# City of Tualatin

## SUBDIVISION REVIEW FINDINGS AND DECISION FOR SB 13-03, PENNINGTON TWO

This staff report recommends approval of a 6-lot plan for the Pennington Two Subdivision, as shown on plans dated May 16, 2013 attached as Exhibit B, with conditions of approval as outlined in the staff report.

SITE PLAN

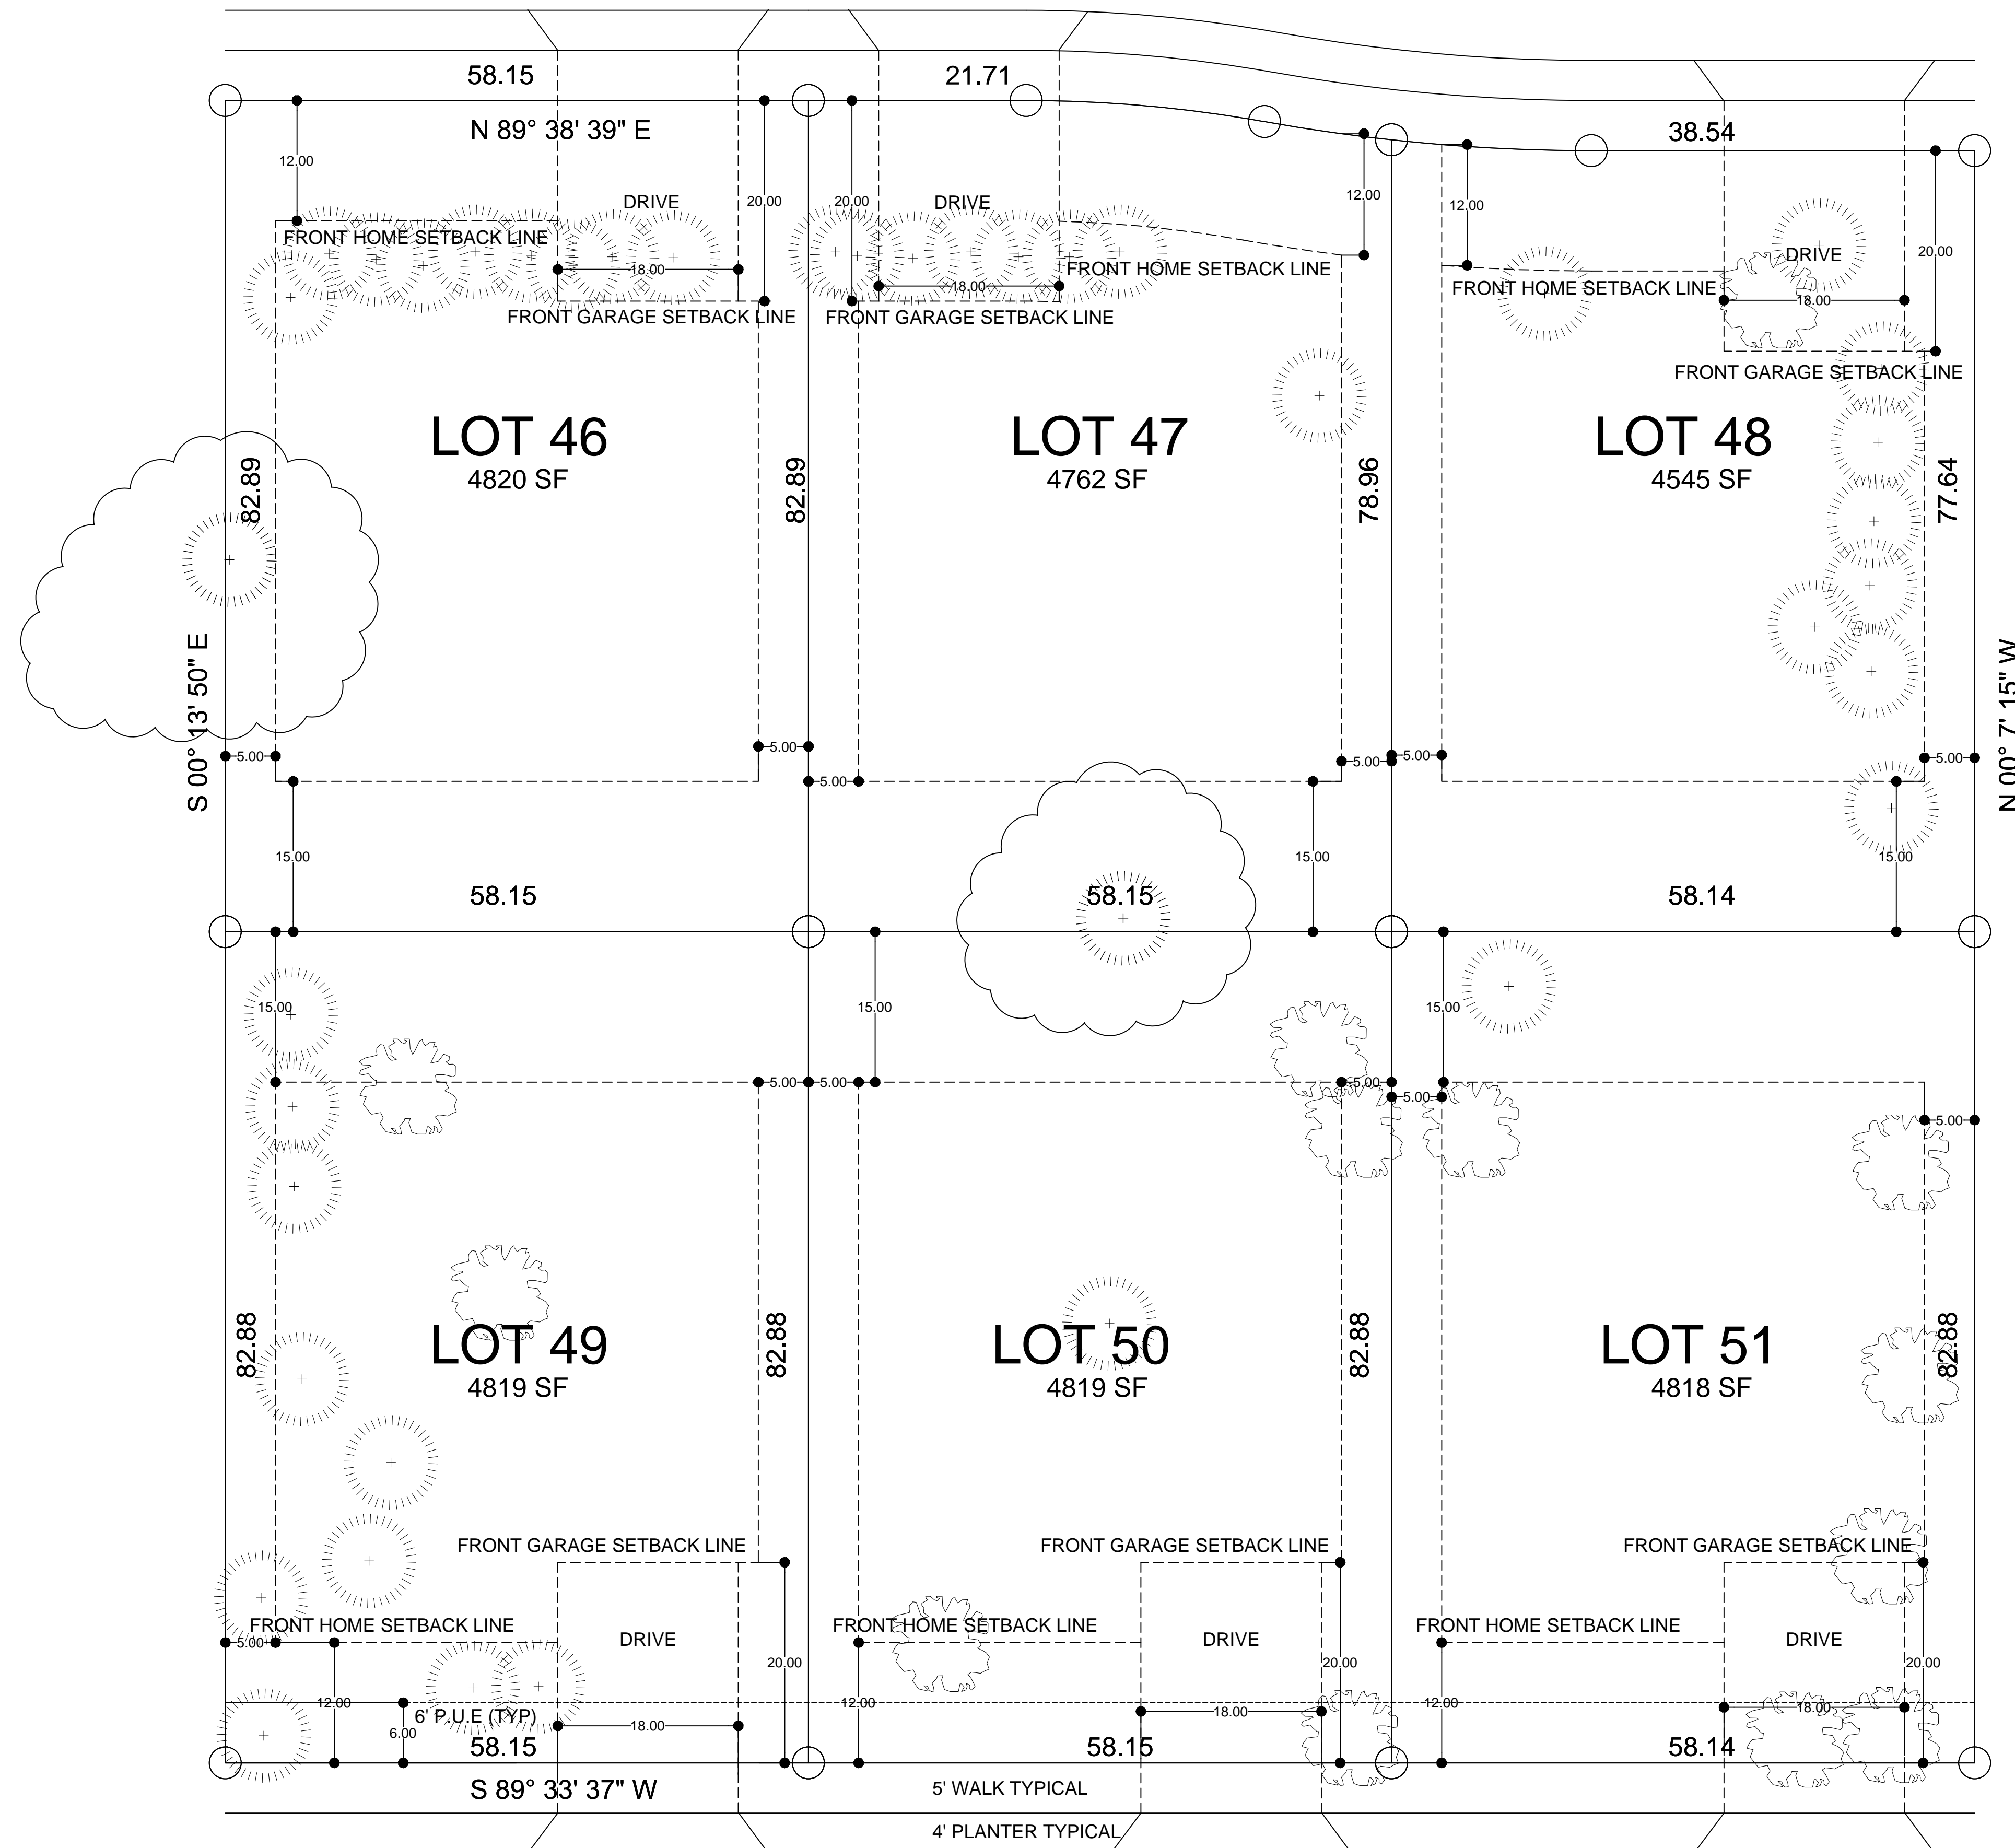
The plans show each lot to have an 18-foot wide access to a public street, greater than the 10-foot minimum and less than the 26-foot maximum for a two car garage. This is acceptable. The applicant will need to submit final plans showing all driveways, for review and approval.

The applicant has submitted an arborist report dated January 29, 2013. This report recommends 2 trees for preservation, numbers 18 and 35. The submitted plans only show preservation of trees numbered 18 and 35. Conditional Use Permit CUP 13-01, accepted by City Council May 13, 2013, provided permission for a small-lot subdivision on this lot with preservation of an additional seven specific trees. The trees required to be preserved as identified on the submitted arborist report are numbers 1, 2, 6, 17, 36, 43, and 47. The plans need to show preservation of all required trees. The applicant will need to submit revised plans that show preservation of trees identified on the submitted arborist report as numbers 1, 2, 6, 17, 18, 35, 36, 43, and 47, for review and approval.

The submitted plans do not show public fire hydrants. Three public fire hydrants exist near this site: on the north side of SW Quinault Lane opposite this development, at the intersection of SW 94<sup>th</sup> Terrace & SW Stono Drive, and at the intersection of SW 93<sup>rd</sup> Terrace & SW Stono Drive. All lots are within 400 feet of an existing public fire hydrant. This is acceptable. This requirement is met.

- *The applicant shall show tree protection around trees to be retained identified on the submitted arborist report as numbers 1, 2, 6, 17, 18, 35, 36, 43, and 47, for review and approval.*
